# Addendum #1

Date: July 7, 2015  
Project: Price 2<sup>nd</sup> Floor South HVAC Renovation Re-Bid  
Contract: FD-15-011

# 2ND FLOOR ELECTRICAL CEILING DEMOLITION PLAN

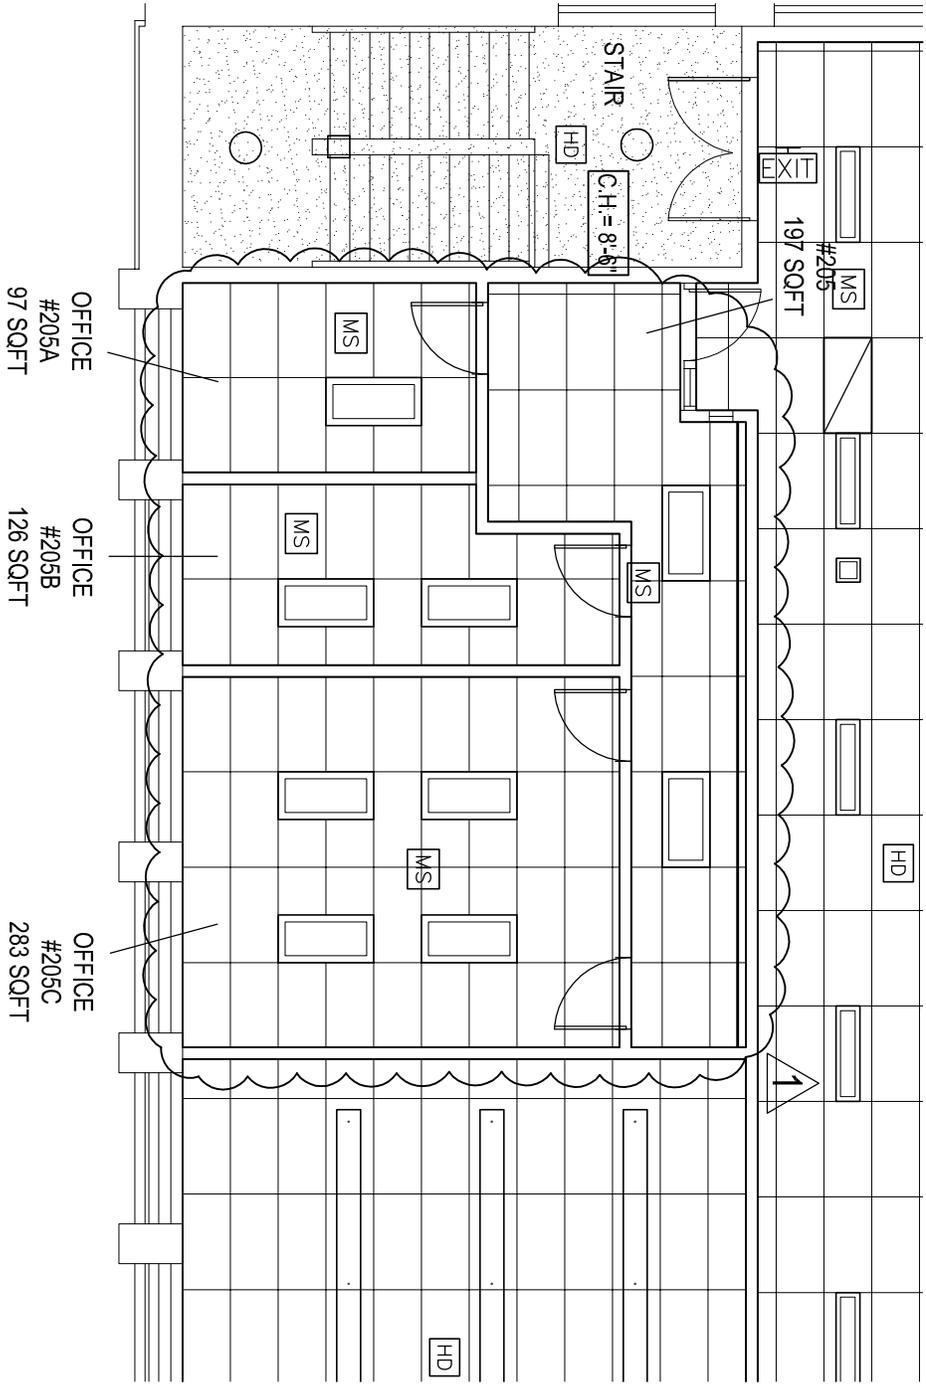
1. Drawing A2.1
  - a. Disregard Demolition Note D-6. Demolition of the existing partition walls in the Graduate Studies Office will be completed by the abatement contractor.
2. Drawing E9.1
  - a. Add ceiling-mounted devices as shown to 2<sup>nd</sup> floor electrical ceiling demolition plan. See sketch SK-E.1, attached.
